### **Addendum No. 1**

## **Capitolo Playground Field Renovations and Site Improvements RFP**

### **Philadelphia Redevelopment Authority**

**Issue Date: August 24, 2021**

**PROJECT NO.** DRAWING NO.  
**P-101**

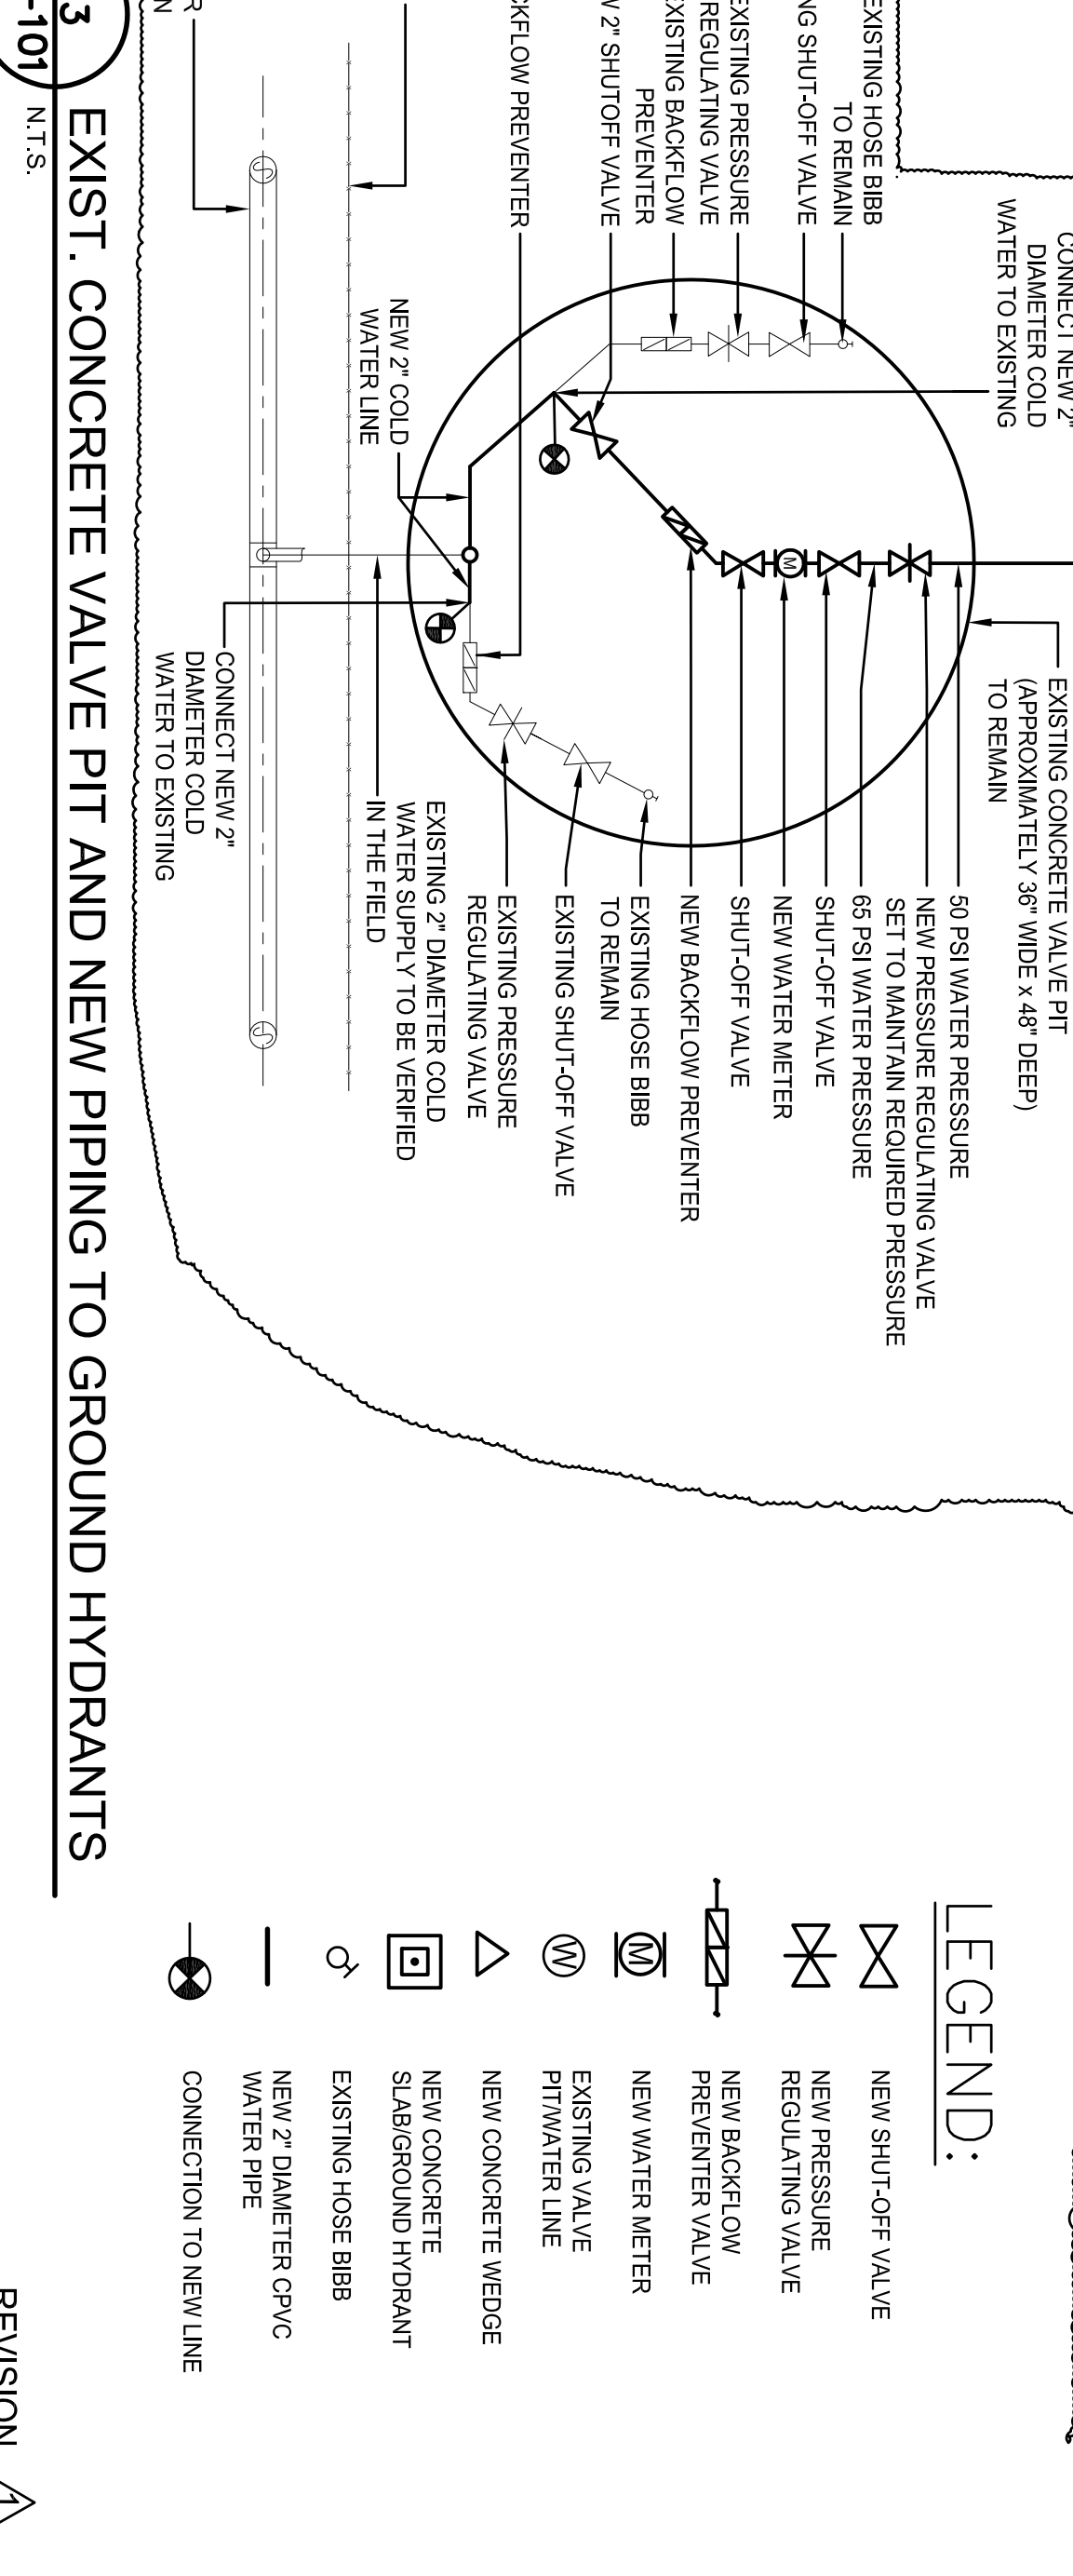
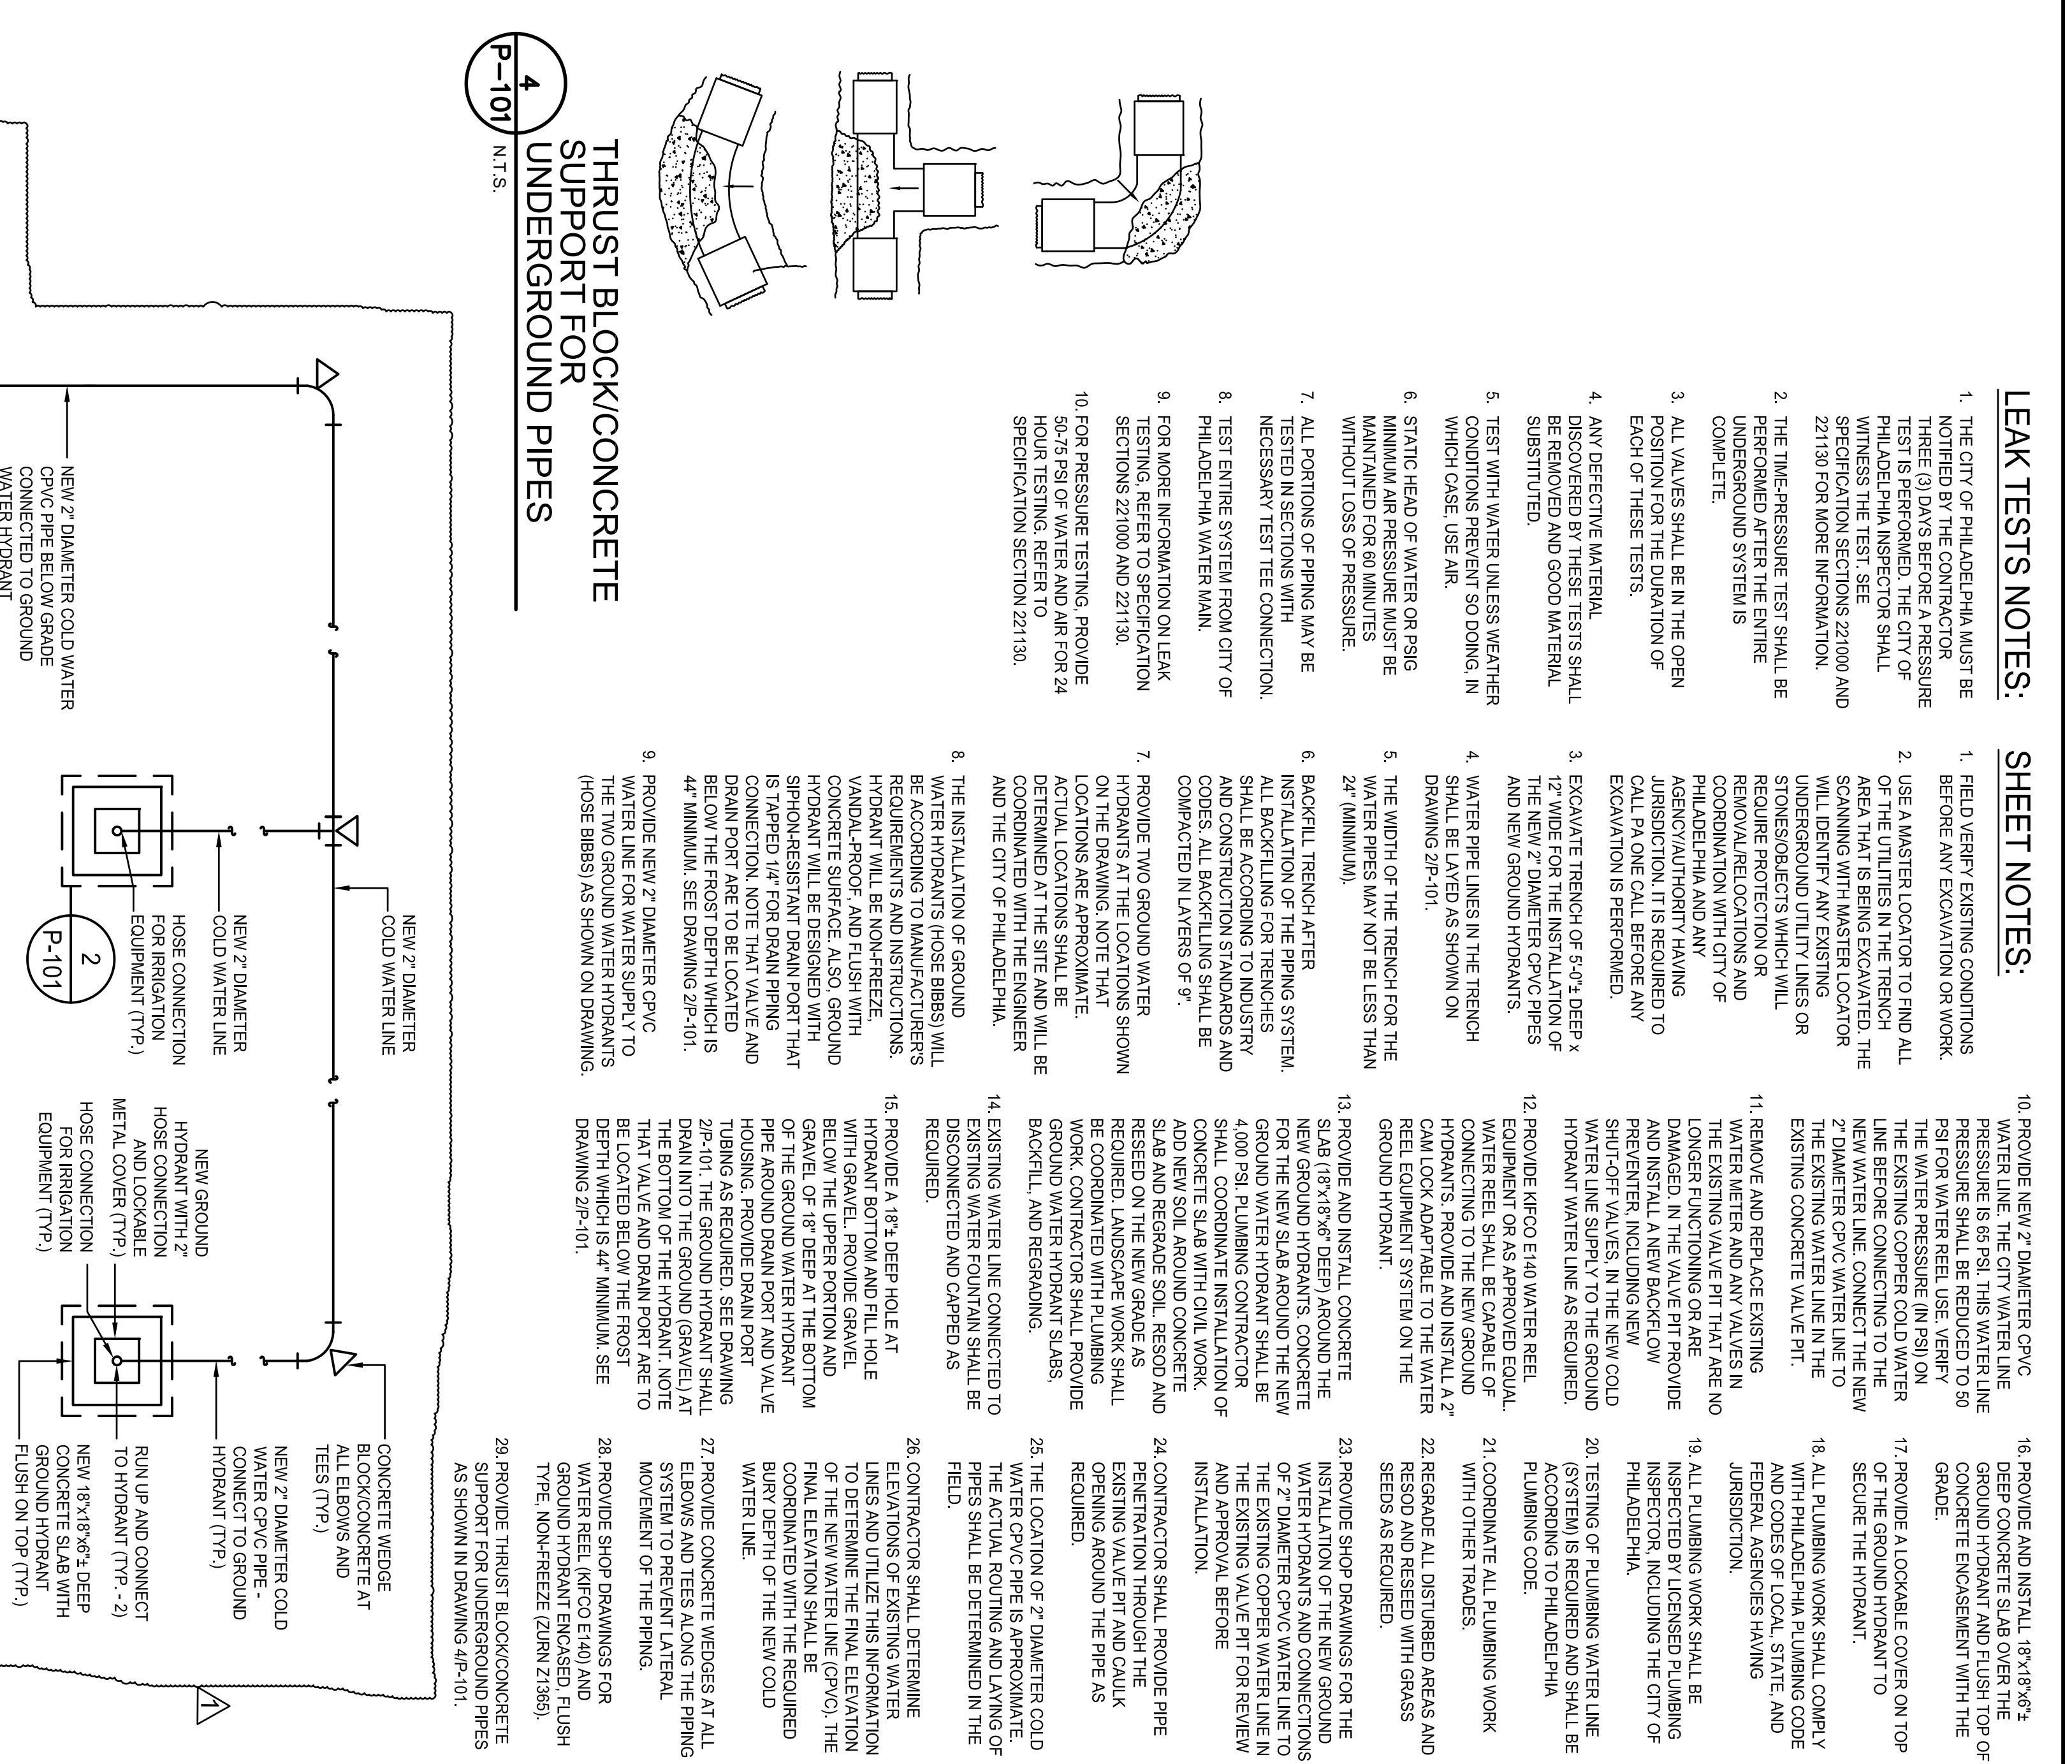
1. Added Specification 221000 (Plumbing System)
2. Added Specification 221130 (Flush Type Ground Hydrant)
3. General Plumbing Notes – Revised
4. Drawing P101 (Plumbing) - Revised
5. Drawing LSK-1 (Demolition Scope) – Note Change
6. Drawing LKS-2 (Dimensions for Garden) – Note Change
7. Drawing LKS-3 - Delete Remnant Notes
8. Drawing LKS-4 – Plaque Location Detail
9. Drawing LKS-5 – Garden Fence Dimensions
10. Questions and Answers

4. The Kifco representative informed me that the B140 Water Reel will not work with a ¾" water line. At a bare minimum this should be a 2" water line but he would recommend a 3" line to fully cover 100,000 sf of sod. His name is Tom Matt and he can be reached at (315) 225-7054 if you wish to discuss with him. Please clarify if we should bid the plans as drawn or figure a new 2" water service connection which will require a meter pit and a hot box with a new backflow preventer.

**ANSWER: The size of the supply water line in the existing valve pit, connected to the ground water hydrant, was changed from 3/4" to 2". This includes the line with the new backflow preventer, new shut-off valves, new water meter, new pressure regulating valve.**

sketch no. LSK-1

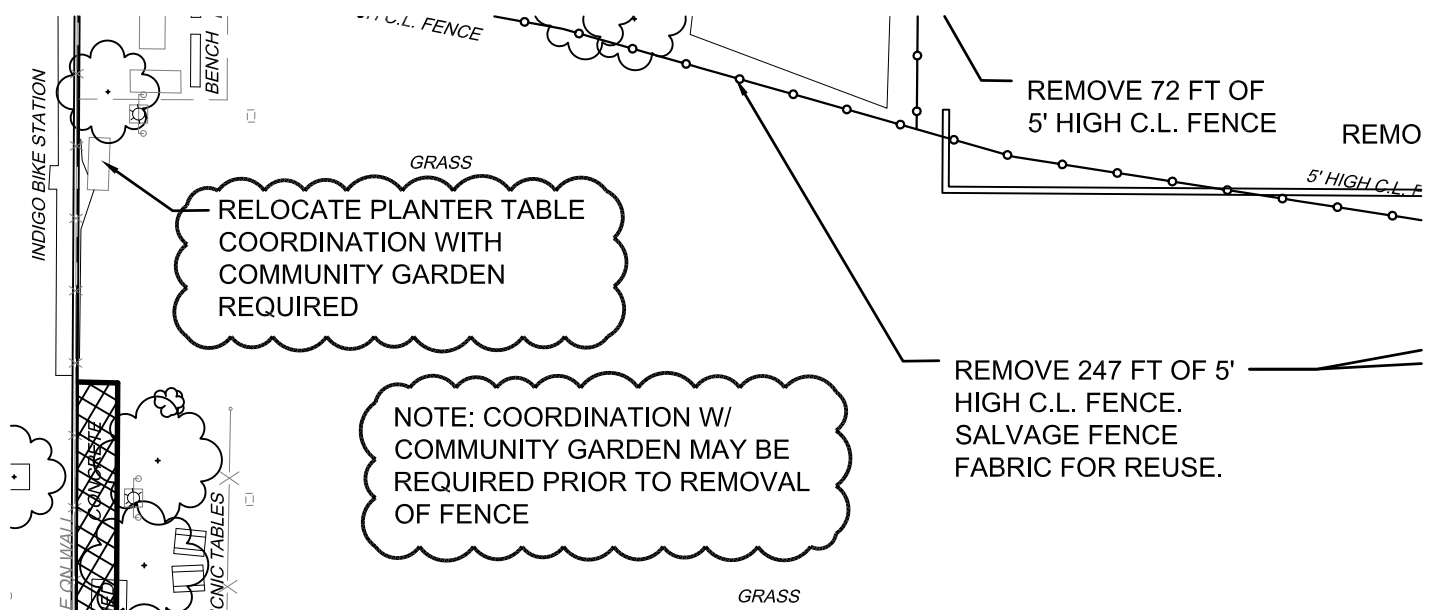
title Demolition Scope and Note Changes

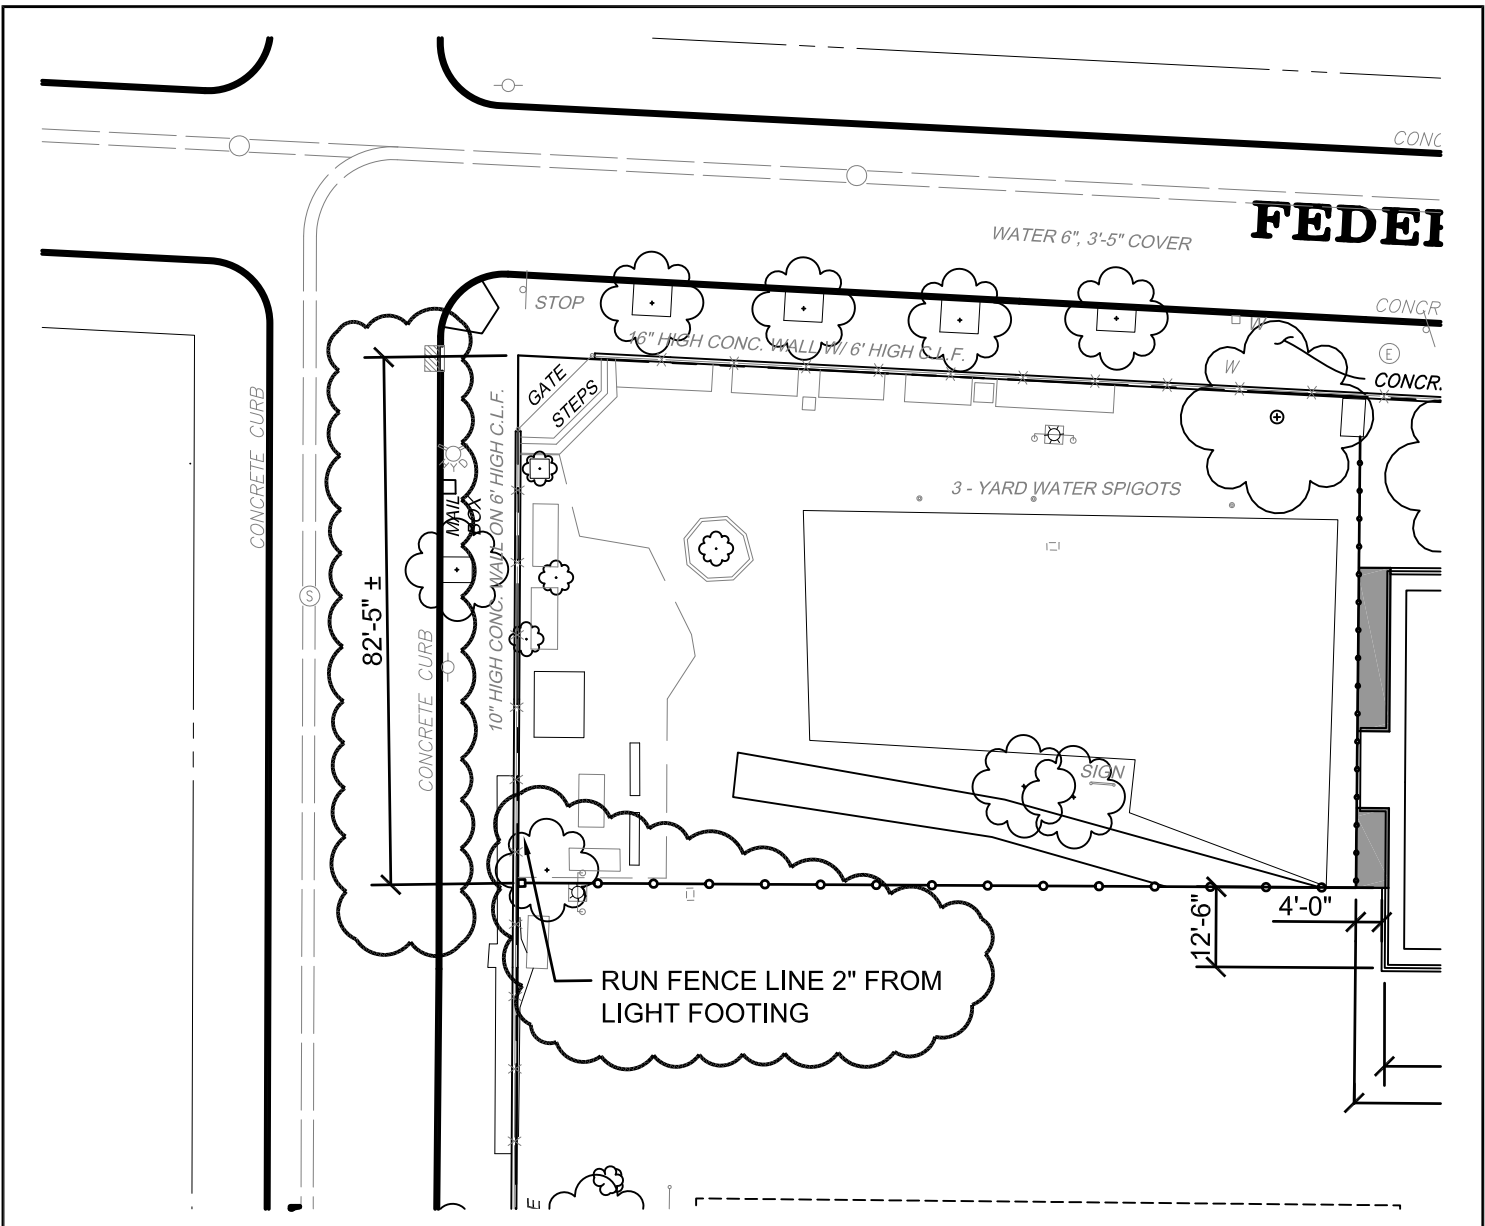
<b>PROJECT TITLE</b>  <b>Rebuild</b> <b>CAPITOLO PLAYGROUND</b> <b>FIELD RENOVATIONS</b>	<b>date</b> August 23, 2021	<b>drawn by</b> Synterra Ltd.	<b>scale</b> as shown
	<b>project</b> Rebuild CAPITOLO PLAYGROUND FIELD RENOVATIONS	<b>project no.</b> 16150E-05-02	
	<b>title</b> Dimensions for Garden Fence	<b>reference drawing no.</b> L-103	
	<b>issue:</b> ADDENDUM # 1	<b>sketch no.</b> LSK-2	
		<b>sheet</b> 2 of 4

sketch no. LSK-3

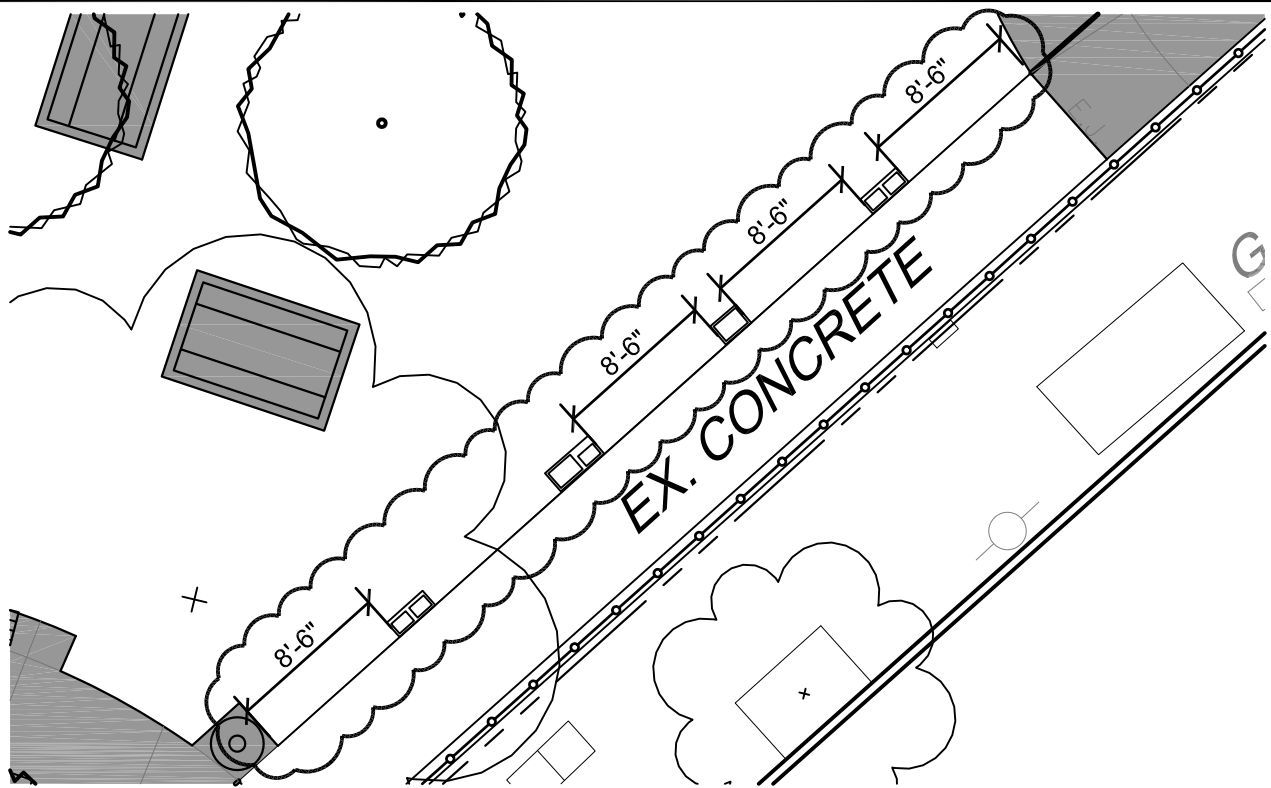
title Delete Remnant Label
